RENESAS TECHNICAL UPDATE

Product Category	MPU/MCU		Document No.	TN-RZ*-A0092A/E	Rev.	1.00
Title	RZ/G2H, G2M V1.3, V3.0, G2N and G2E Document corrections for Booting		Information Category	Technical Notification		
Applicable Product	RZ/G Series, 2nd Generation	Lot No.	Reference Document	RZ/G Series, 2nd Generation User's Manual: Hardware Rev.1.10 (R01UH0808EJ0110)		
	RZ/G2H RZ/G2M V1.3, V3.0 RZ/G2N RZ/G2E	All lots

Document corrections for "RZ/G Series, 2nd Generation User's Manual: Hardware Rev.1.10".

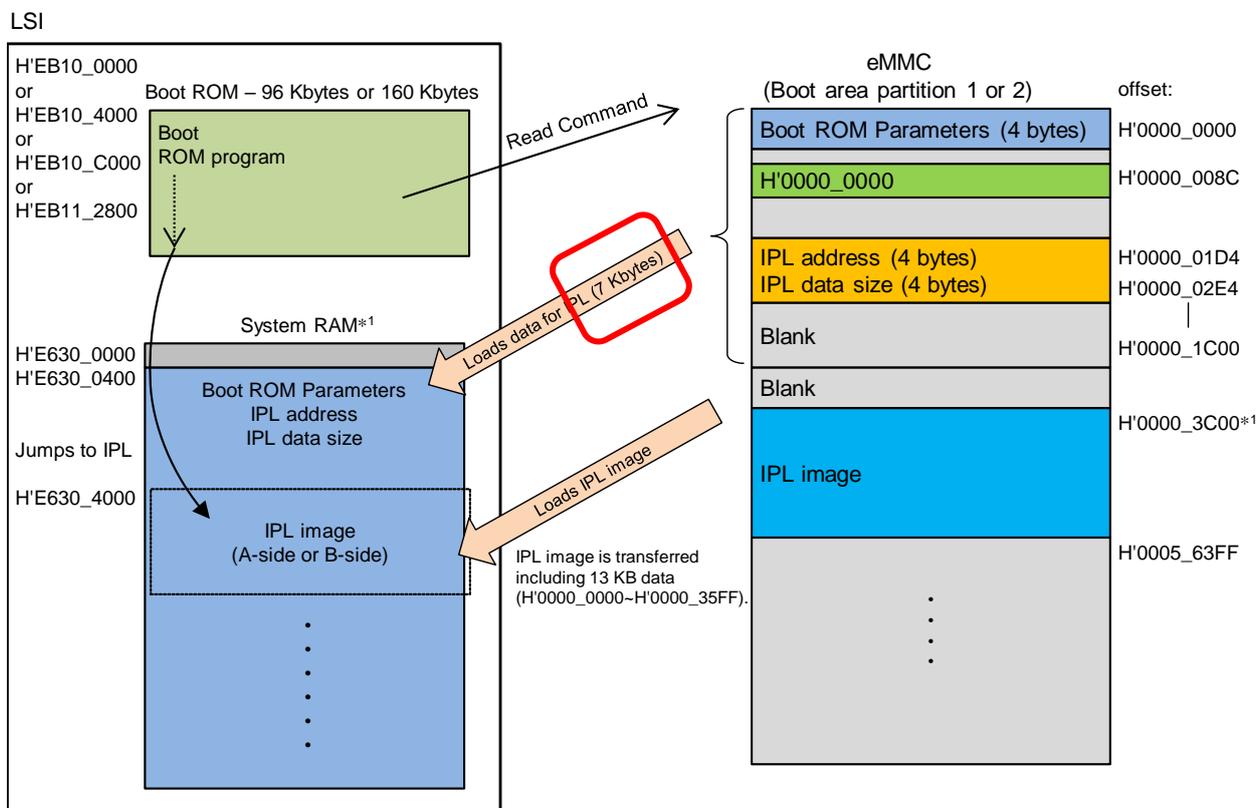
2. Section 24. Booting, Page 24-12, 24.2.5 eMMC Using DMA Boot Sequence, Boot ROM size is corrected.

1. The master boot processor jumps to H'EB10_0000 (RZ/G2H, RZ/G2M V1.3, RZ/G2M V3.0, RZ/G2N, RZ/G2E AArch32) or H'00_EB10_C000(RZ/G2M V1.3, RZ/G2M V3.0 AArch64) or H'00_EB11_2800 (RZ/G2H, RZ/G2N, RZ/G2E AArch64). The processor executes the instructions in Boot ROM and **3KB** data are transferred from eMMC to System RAM using MMC's DMA with 512-Byte transfer size.
2. These **3KB** data contain Boot parameters, address information and data size information of IPL.
3. The amount of data specified by data size information is transferred to System RAM. After the transfer, the master processor jumps to the address specified by address information of IPL.

Correction of transfer size.

1. The master boot processor jumps to H'EB10_0000 (RZ/G2H, RZ/G2M V1.3, RZ/G2M V3.0, RZ/G2N, RZ/G2E AArch32) or H'00_EB10_C000(RZ/G2M V1.3, RZ/G2M V3.0 AArch64) or H'00_EB11_2800 (RZ/G2H, RZ/G2N, RZ/G2E AArch64). The processor executes the instructions in Boot ROM and 2KB data are transferred from eMMC to System RAM using MMC's DMA with 512-Byte transfer size.
2. These 2KB data contain Boot parameters, address information and data size information of IPL.
3. The amount of data specified by data size information is transferred to System RAM. After the transfer, the master processor jumps to the address specified by address information of IPL.

Figure 24.6 IPL transfer and Program image(eMMC)

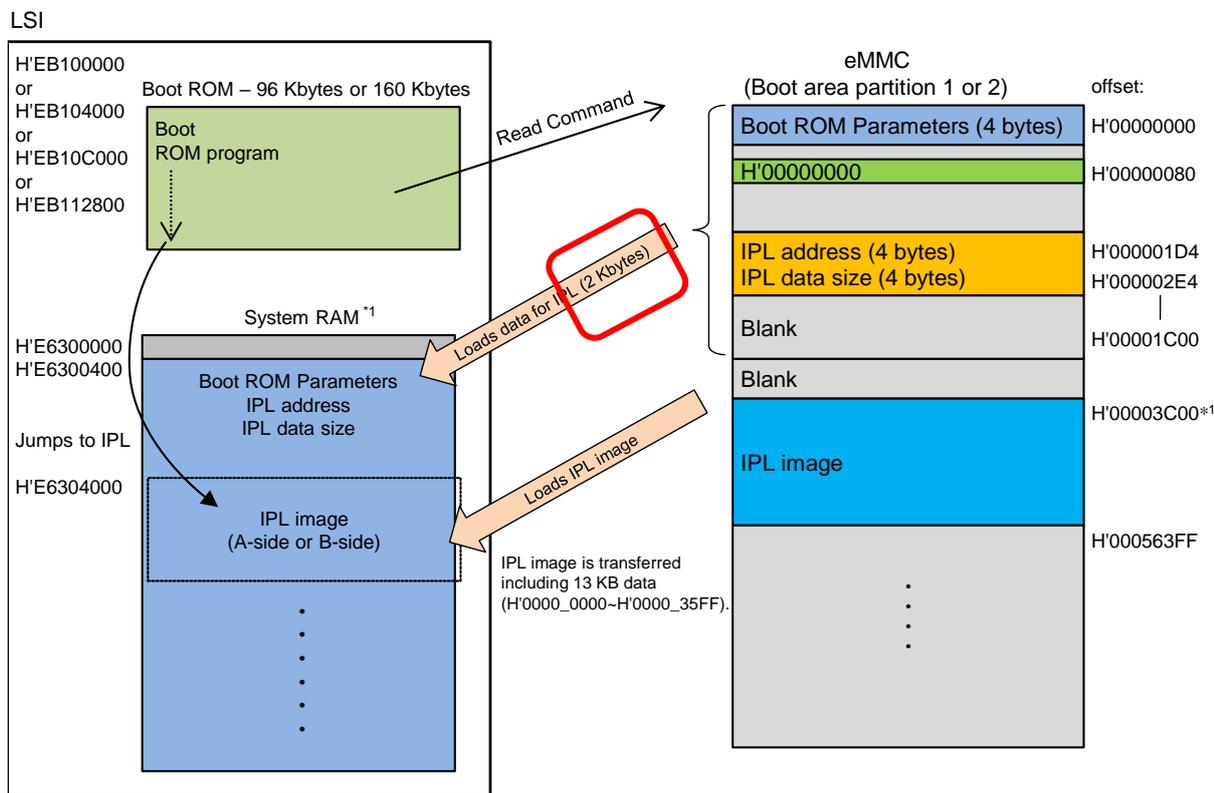
3. Section 24. Booting, Page 24-14, 24.2.5 eMMC Using DMA Boot Sequence, Boot ROM size is corrected.

Note 1: The offset address of IPL image is calculated as "IPL address - H'E630_0400"

Correction of transfer size.

Note 1: The offset address of IPL image is calculated as "IPL address - H'E6300400"
